Determination 2015/029

Regarding the issue of a notice to fix and the refusal to issue a code compliance certificate for 11-year-old alterations to a 1970s solid timber house at 86 Koneburn Road, Waimanu

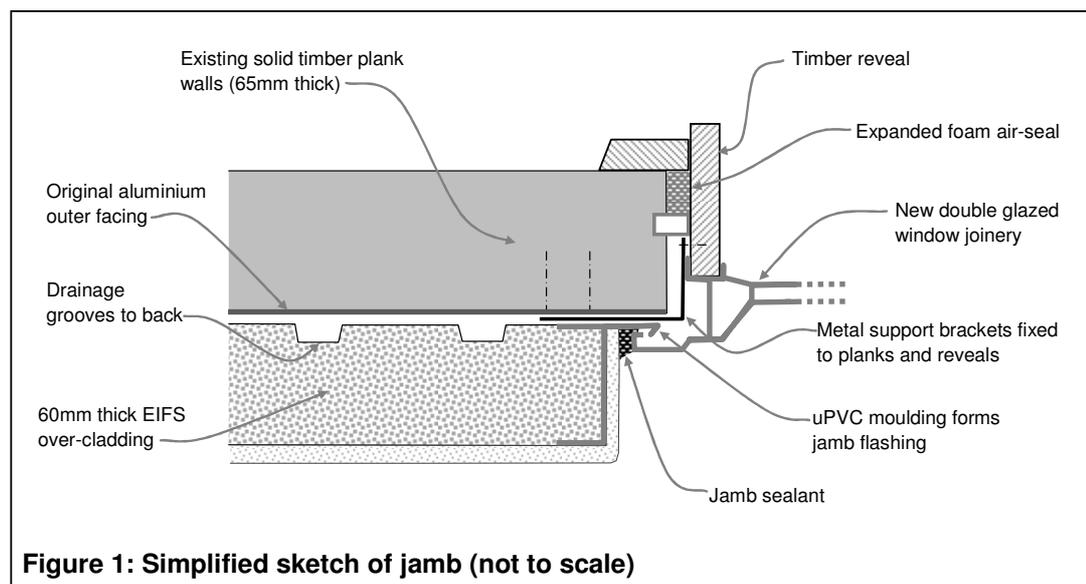
2.4.2 In the case of the addition, the EIFS system is fixed directly to the framing over the building wrap. In the case of the original house, EIFS is installed over the solid wall planks, with the new aluminium double glazed windows installed as shown in Figure 1.

- In comparison with the original windows, the new windows (see Figure 1) include head, jamb and sill flashings within the EIFS system and can be expected to achieve at least the same level of protection to the junctions.

- 8.4.3 Taking account of the above observations and the nature of the building work as alterations, I am satisfied that the over-cladding and the new window junctions provide weathertightness and durability to at least the same extent as before the alteration. I am therefore able to conclude that this building work complies with Clauses E2 and B2 to the extent required by the current Act.
